TOWNSHIP OF ABINGTON

Consider approving the Land Development Application submitted by ABH Builders, Inc. for the Vacant Property located at 1043 Easton Road, Abington, PA 19001.

Re: Land Development Plan submitted for Parcel #300014488008, Block #195, Unit #015, known as Application LD-18-01.

Re: 18-0015-001
Easton Road Tax Block 195 Unit 15
(4 Dwelling Units on 0.44 acres)
Situate: Edge Hill Road (N), Easton Road (E)
Abington Township

LAND DEVELOPMENT PLAN
 PREPARED FOR
TAX BLOCK 195 UNIT 15

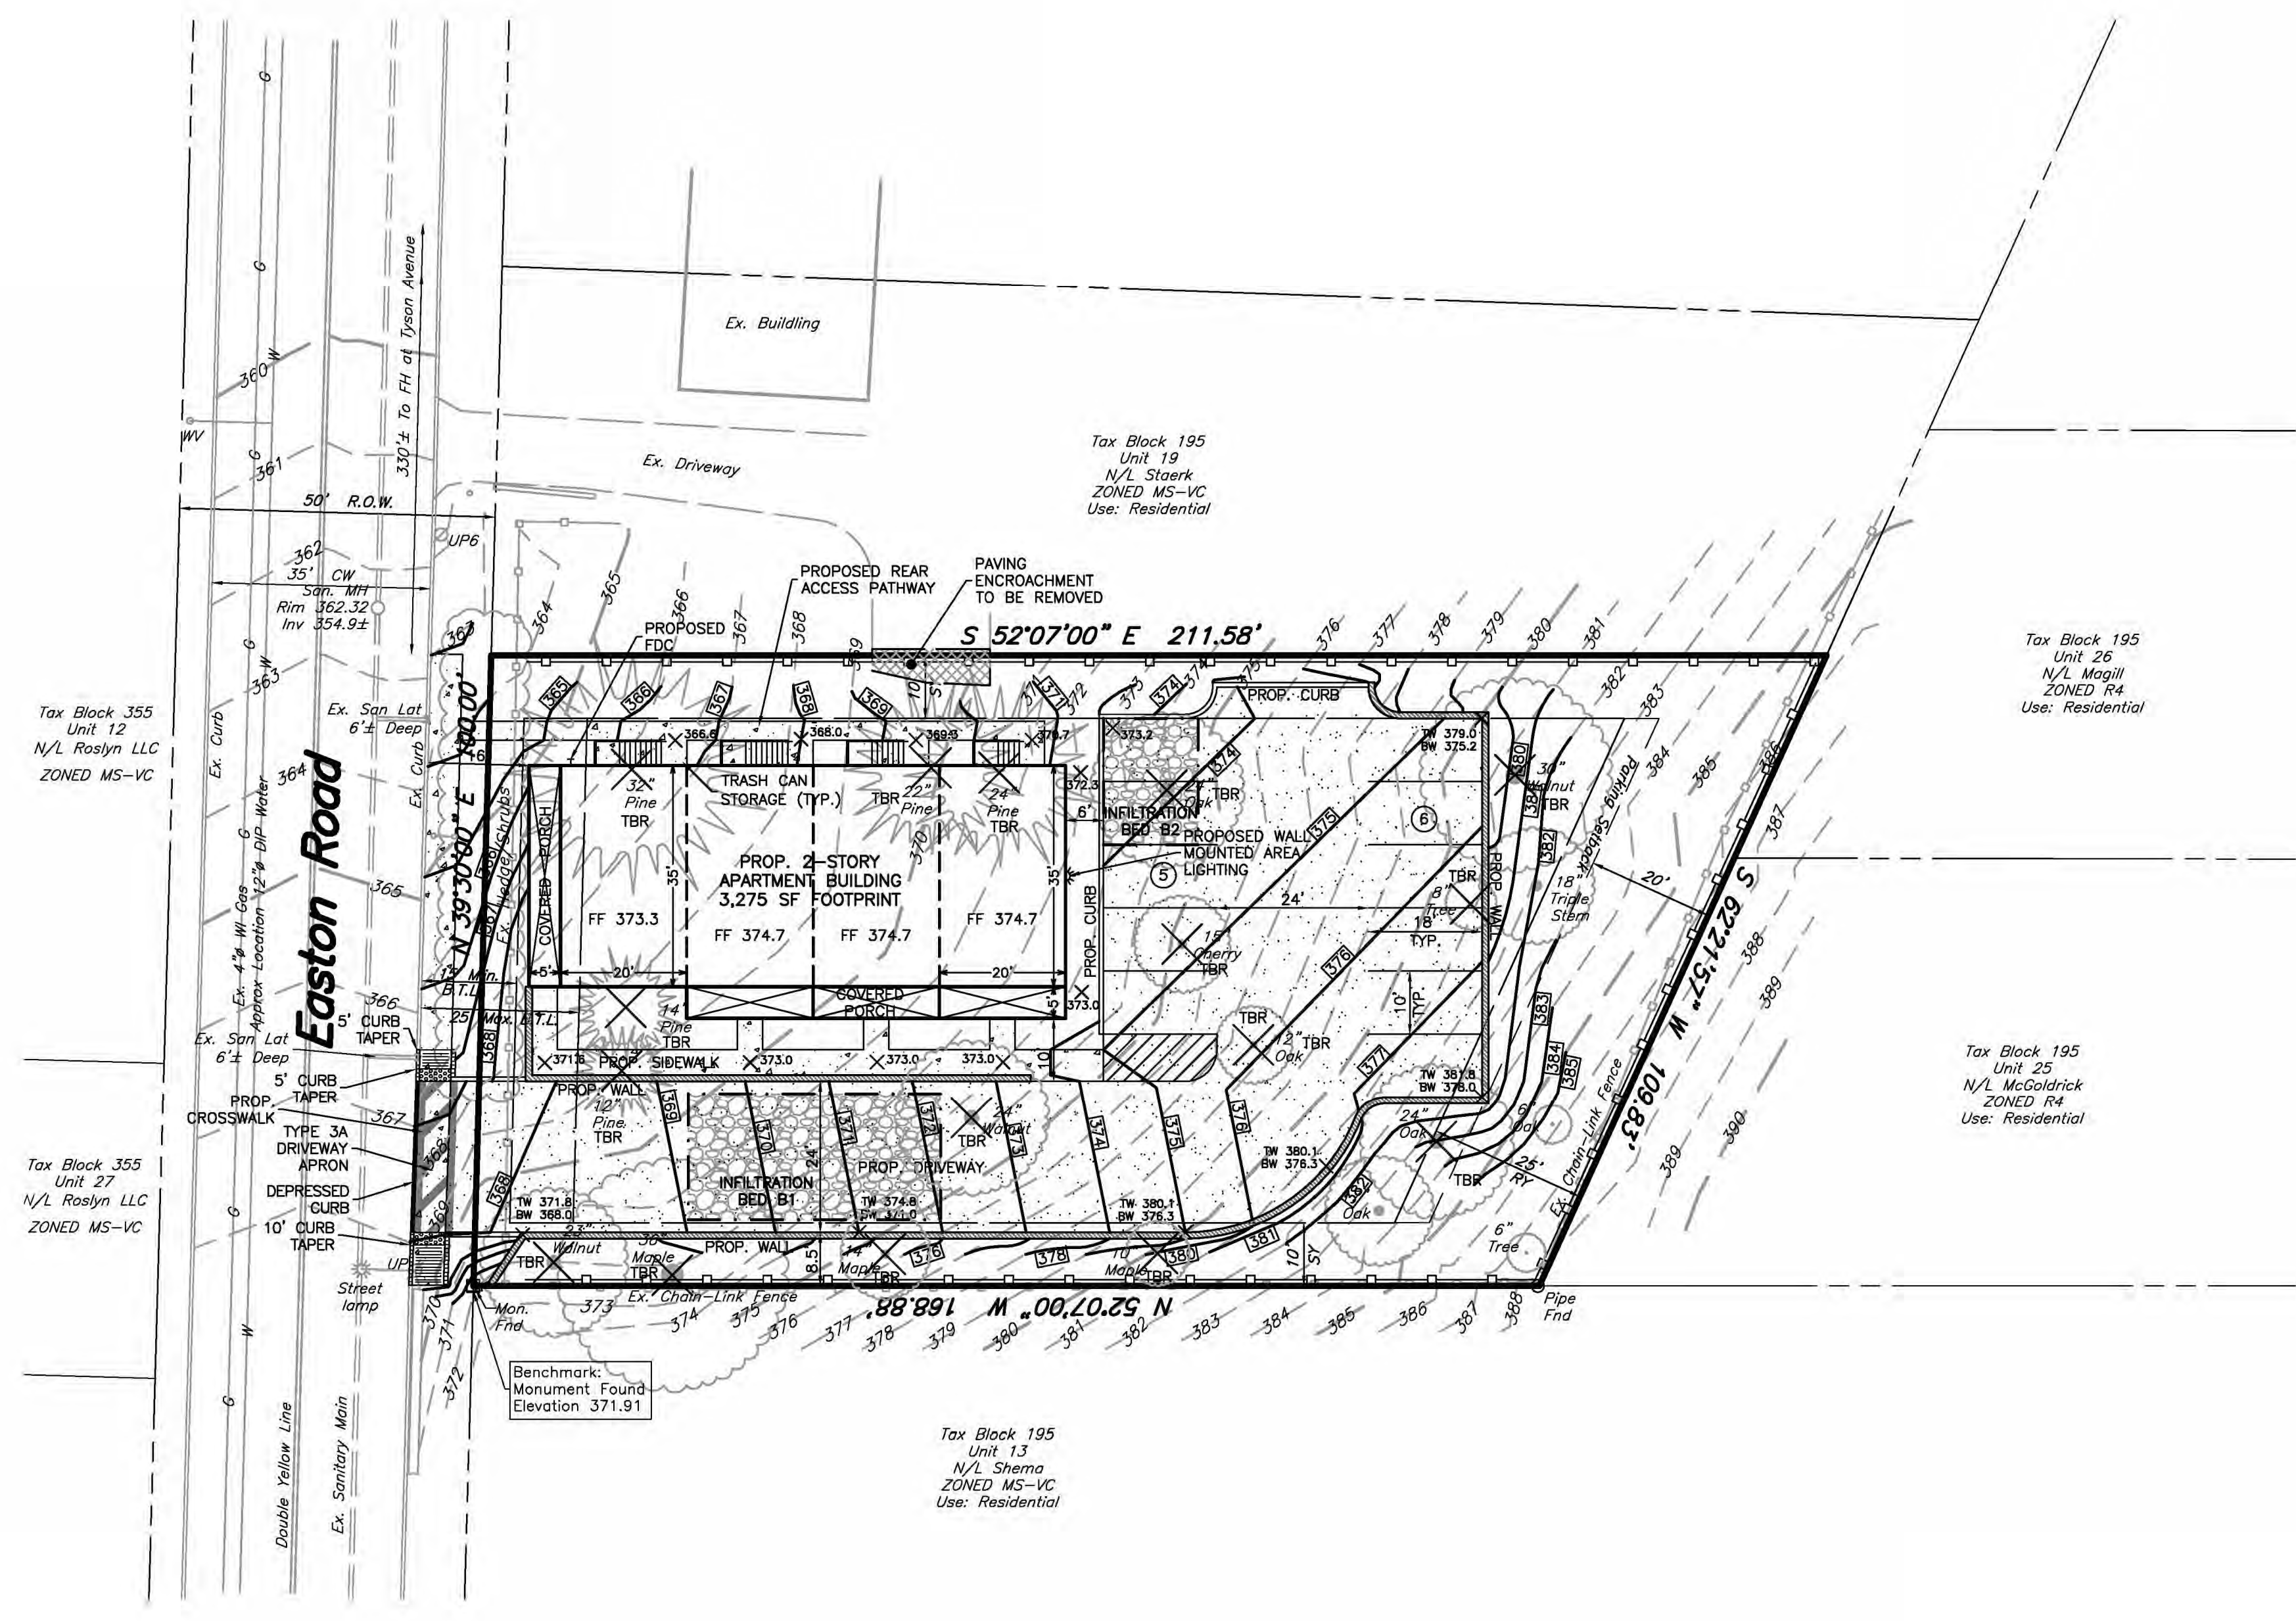
18. The applicant submitted a dimensional requirements chart on Sheet #1 that shows compliance with the dimensional requirements of Figure 10:20 of the Zoning Ordinance. However, this office is unable to confirm compliance with the requirements of Section 1007 {Design Standards} of the Zoning Ordinance. The applicant is required to submit the required detailed plans so that a compliance review can be completed.
